# WESTERN NUCLEAR, INC.

**RE: Radon-222 Flux Measurements on the Sherwood Tailing Impoundment Surface After Final Cover Placement.**

In a letter dated August 20, 1999, from WDOH, a total of 12 issues were raised relative to soil erosional stability and riprap placement. A site meeting was held on September 7 with WDOH and WNI representatives. This meeting resulted in a plan to address the 12 issues raised in the August 20 letter. A letter was transmitted from WNI to WDOH on September 16, 1999, that described the actions to be taken to address each issue. A September 21, 1999, letter from the WDOH acknowledged receipt of the September 16 letter and presented WDOH's position on each of the issues.

# SHERWOOD PROJECT RESPONSES TO WDOH COMMENTS ON THE DECEMBER 1994 TAILING RECLAMATION PLAN

**FIGURE 1**

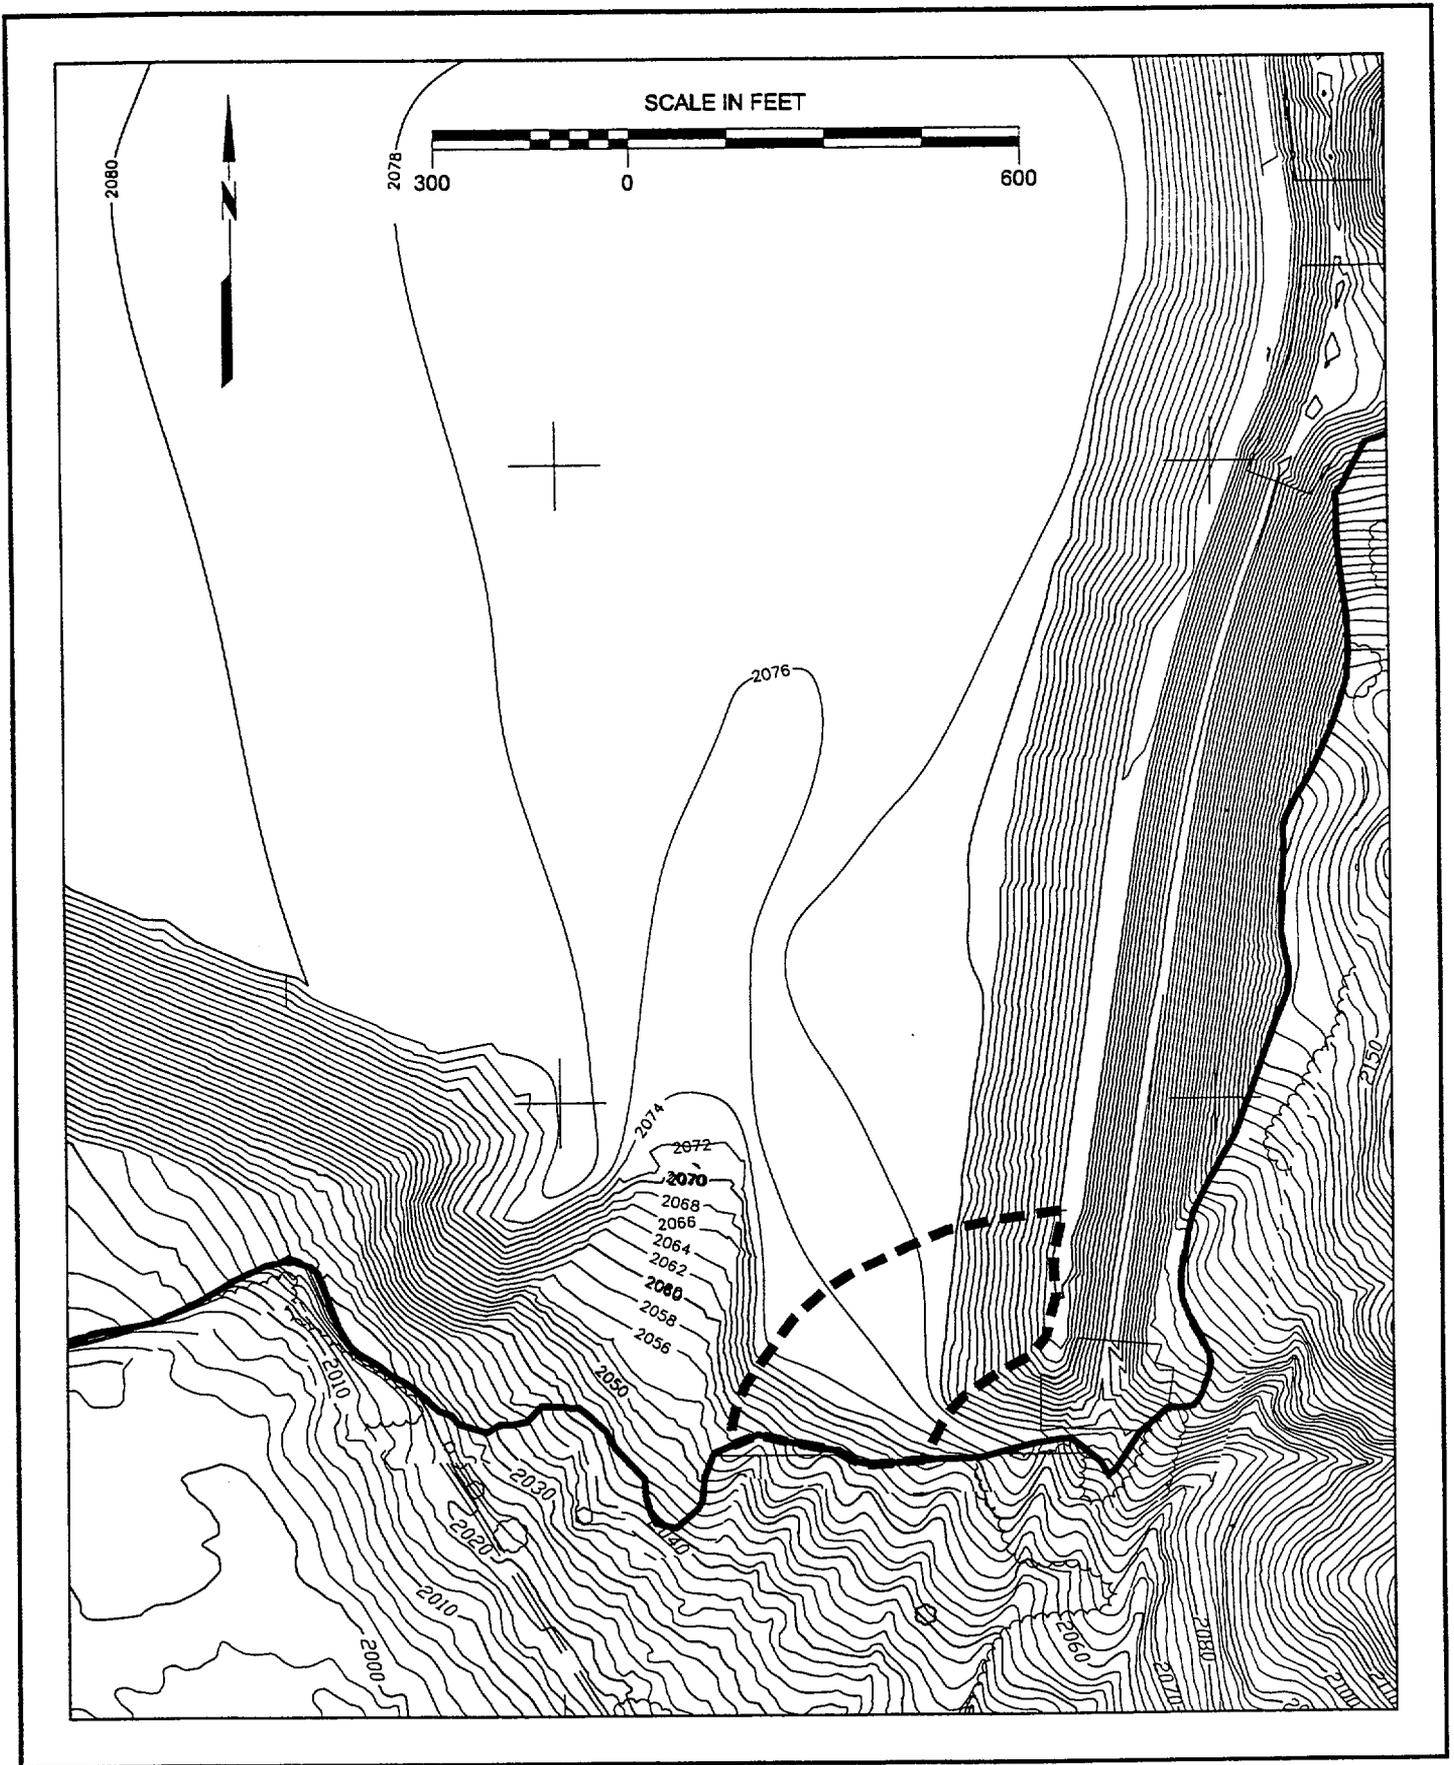
## RESPONSE

There is a small area (approximately 3 acres) between the swale outlet and the margin, as shown on Figure 1, that drains to the south. This drainage configuration is consistent with the original design. As the regraded gentle slope transitions into the steeper natural topography, a small amount of gullying and general erosion is apparent. This erosion will not, however, impact the reclaimed tailing impoundment. Any head-cutting would be limited to the small drainage basin, which is at least 700 feet from the edge of the reclaimed tailing surface. Additionally, quartz monzonite bedrock is at or near the surface for much if not all of this small drainage basin and therefore any gullying would be limited to a depth of only a few inches.

FIGURE 1  
TYPICAL CROSS SECTION

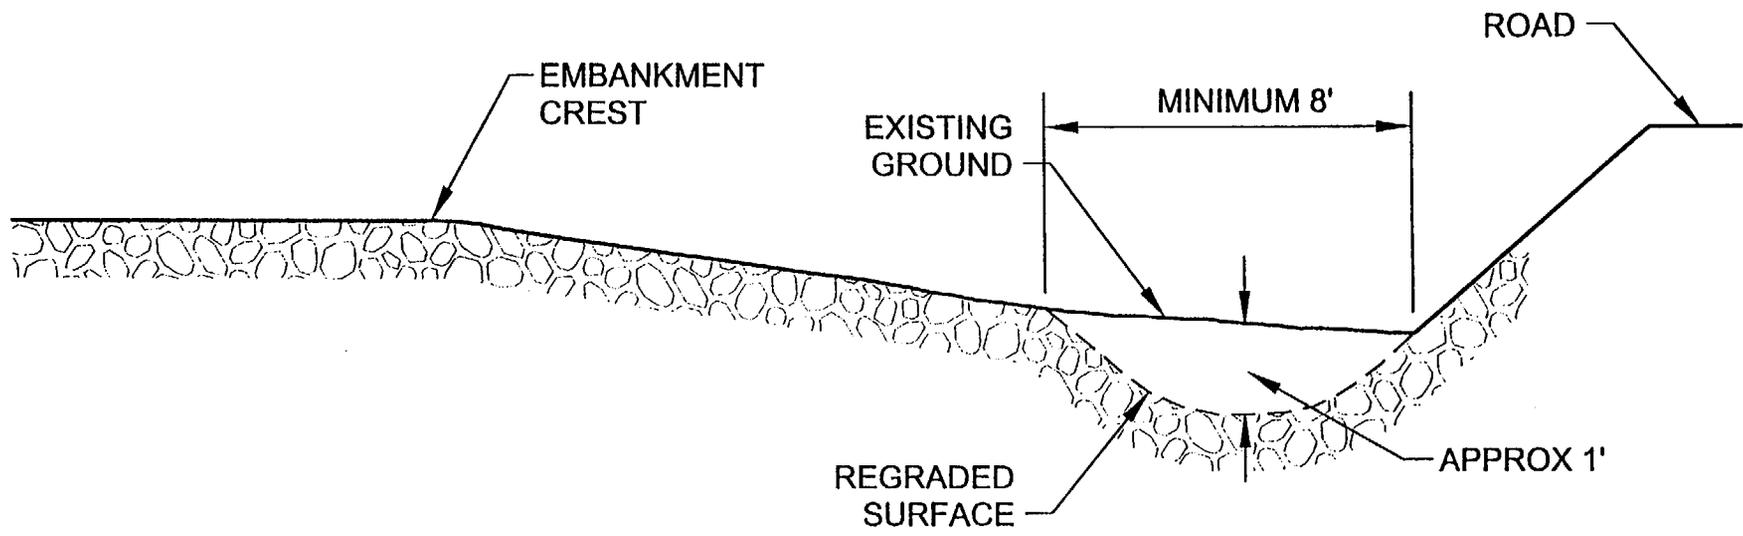
This letter is in response to your letter dated September 21, 1999 regarding surface stability inspection issues at the Sherwood project site. Specifically this letter presents the required design to address the regrading activities for Issue 1, the area immediately west of the reclaimed embankment and Issue 3, the reclaimed northwest borrow area.

As discussed during our site inspection on September 7, 1999 this concern will be addressed by enlarging the existing drainage to the south to keep drainage water away from the groin area. This will be done by removing the existing rock in the drainage, excavating the subsoil material and replacing the existing rock. Figure 1 depicts a typical cross section of the reconfigured drainage.

FIGURE 5.1  
DIVERSION CHANNEL  
SCHEMATIC

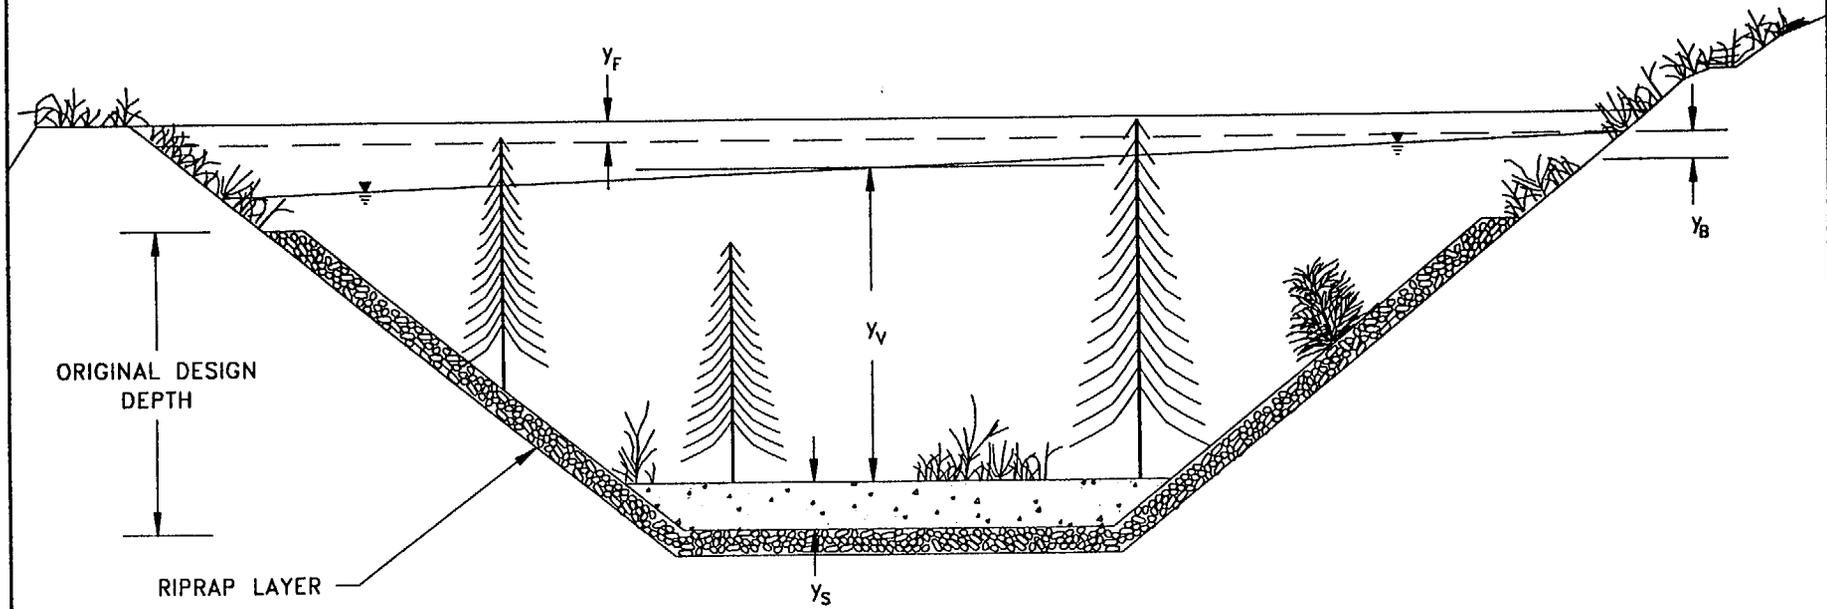
## 5.0 DIVERSION CHANNEL DESIGN MODIFICATION

Since relocation or deletion of the diversion channel are not beneficial alternatives, modification to the diversion channel design in the 12/94 TRP, is proposed to ensure that the channel will contain 1) 2.0 feet of sediment deposited on the bed, 2) PMF flows through a vegetated channel as modeled by HEC-2 with Manning's n equal to

0.10, 3) superelevation, and 4) 1.0 foot of freeboard. The 1.0 foot of freeboard in addition to considerations for sediment, vegetation, and superelevation, is a final degree of conservatism and provides significant cross sectional area to the channel should it be needed. For example, at the downstream end of the channel, the depth is 22 feet and the top width is 140 feet wide. The cross sectional area in the upper 1-foot of channel is about 137 square feet. This area corresponds to a depth of over 5.8 feet at the bottom of the channel. Therefore, there could be as much as 5.8 feet of sediment in the channel and the PMF would still be contained within the channel freeboard.

Figure 5.1 shows the modified channel design schematically. The design of the diversion channel is proposed to be modified by increasing the amount of compacted fill on the berm between the channel and the tailings impoundment. Table 5.1 summarizes the changes in design depth for the channel, comparing channel depth as presented in the 12/94 TRP to the modified channel depth designed for sediment, vegetation and superelevation. Table 5.2 is a more detailed summary of the issues investigated in this response report.

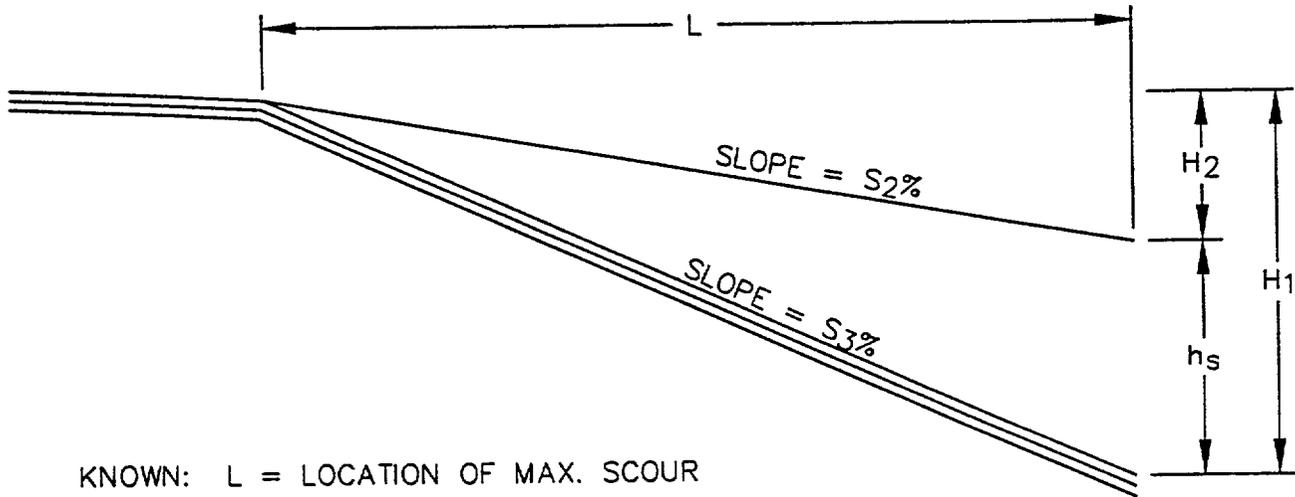
Drawing 7 of the WDOH approved Technical Specifications presents plan and profile views of the Tailing Cover Impoundment Swale Outlet. That drawing indicates that the buried apron of the outlet requires a slope of 15%, a scour depth of 4.5 ft and a length of 30 ft. A survey of the finished swale outlet structure has indicated dimensions that vary somewhat from the Drawing 7 dimensions.

(a) The design slope in Drawing 7 of the WDOH approved November, 1996 Technical Specifications is shown as 15%. This slope was calculated by dividing the scour depth  $h_s$  (4.5 ft) by the length (L)(30 ft). This value is incorrect because as shown in Figure O-1, the slope is equal to the depth  $H_1$  divided by L. As discussed below the correct slope is 21%.

As illustrated in Figure O-1, the slope of the tailing swale apron ( $S_3$ ) is equal to the depth  $H_1$  divided by the length L. However, since the value of  $H_1$  is not known, it is necessary to derive an equation for  $S_3$  in terms of the ground slope  $S_2$  and the scour depth  $h_s$  which are known values. The equation as derived on Figure O-1 is as follows:

The swale apron slope is shown in Drawing 7 of the November 1996 Technical Specifications as 15%. This value is in error because as stated in the footnote in Table O-1, an incorrect depth was used in the slope calculation. Using the equation above results in a correct slope of 21%.
